**Date of Issue:** December 13, 2018

**Affected Publication:** API SPECIFICATION 5CT, *Casing and Tubing*, 10<sup>th</sup> Edition, June 2018

## Errata 1

Figure D.14—Measuring End Straightness

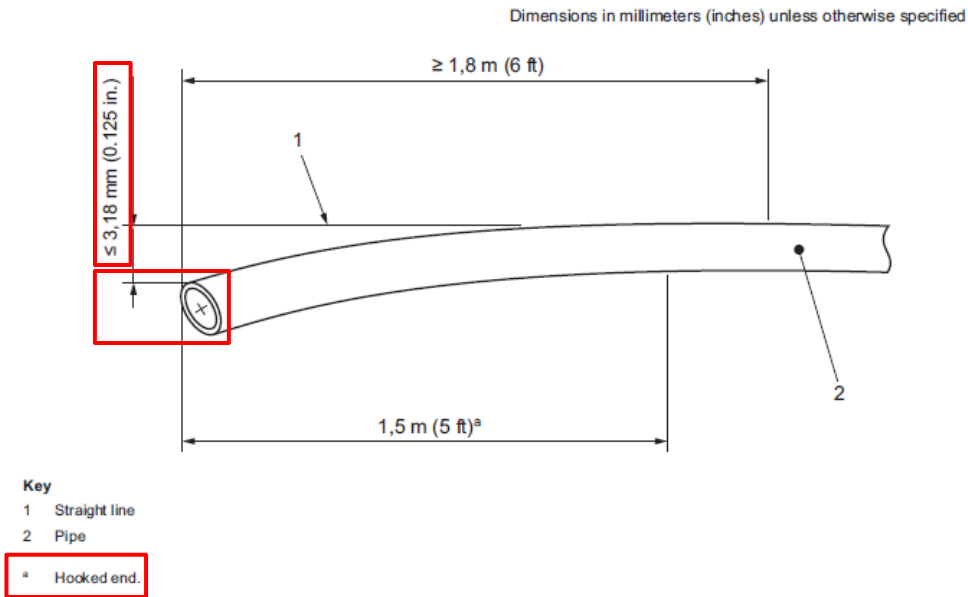
Figure D.14: The figure shall be updated as indicated within the red boxes:

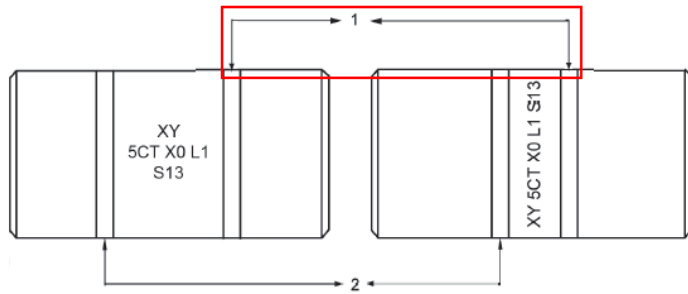
Figure D.22 (continued): The figure title shall be revised as indicated within the red boxes:
